**PLANNED UNIT DEVELOPMENT &  
SUBDIVISION STAFF REPORT****Date: November 3, 2016**

<b><u>NAME</u></b>	Dauphin Gate Subdivision
<b><u>SUBDIVISION NAME</u></b>	Dauphin Gate Subdivision
<b><u>LOCATION</u></b>	3250 Dauphin Street (North terminus of Northgate Drive extending to the South terminus of Sidney Phillips Drive)
<b><u>CITY COUNCIL DISTRICT</u></b>	District 1
<b><u>PRESENT ZONING</u></b>	B-3, Community Business District
<b><u>AREA OF PROPERTY</u></b>	2 Lots / 12.0± Acres
<b><u>CONTEMPLATED USE</u></b>	Planned Unit Development Approval to allow multiple buildings on a single building site and shared access between two building sites, and Subdivision Approval to create two legal lots of record from two metes and bounds parcels.
<b><u>TIME SCHEDULE</u></b>	Upon Approval
<b><u>ENGINEERING COMMENTS</u></b>	<b>Subdivision:</b> <u>FINAL PLAT COMMENTS</u> (should be addressed prior to submitting the FINAL PLAT for acceptance and signature by the City Engineer): <ul style="list-style-type: none"><li>A. Provide all of the required information on the SUBDIVISION PLAT (i.e. signature blocks, signatures, certification statements, written legal description, required notes, legend, scale, b

# SITE PLAN

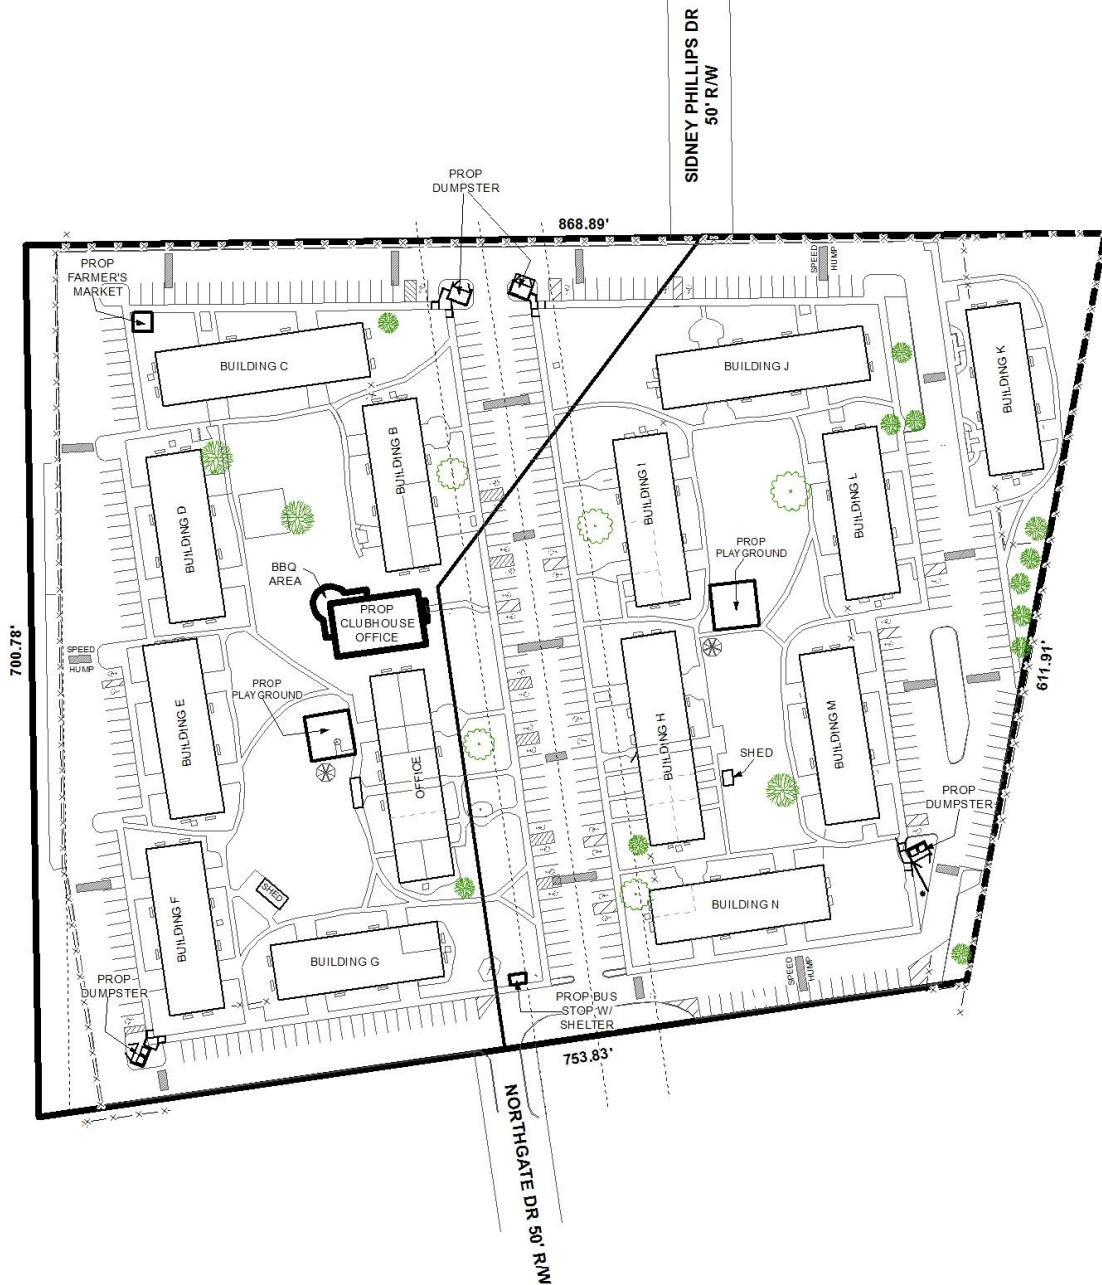
The site is surrounded mostly by B-3, Community Business District and I-1, Light Industry District, however the Northeast portion of the site on the East side of Sidney Phillips Drive is adjacent to property zoned R-1, Single-Family Residential, therefore a residential buffer is required. The site plan indicates a fence along the entire North property line, but makes no mention of the height or material of the fence. The site plan should be revised to indicate that a residential buffer in compliance with Section 64-4.D. of the Zoning Ordinance will be provided where the site is adjacent to R-1 property.

The preliminary plat does not depict the 25' minimum building setback line for either lots along either frontage as required by Section V.D.9. of the Subdivision Regulations. This setback should be depicted on the Final Plat, if approved.

- 1) illustration of the 25' minimum building setback line along both frontages;
- 2) revision of the site plan to indicate a compliant residential buffer where the site abuts R-1 property;

- 3) placement of a note on the site plan stating that both lots are limited to the existing shared curb cut to Northgate Drive with an allowance for an emergency access only entrance if require by the Fire Department;
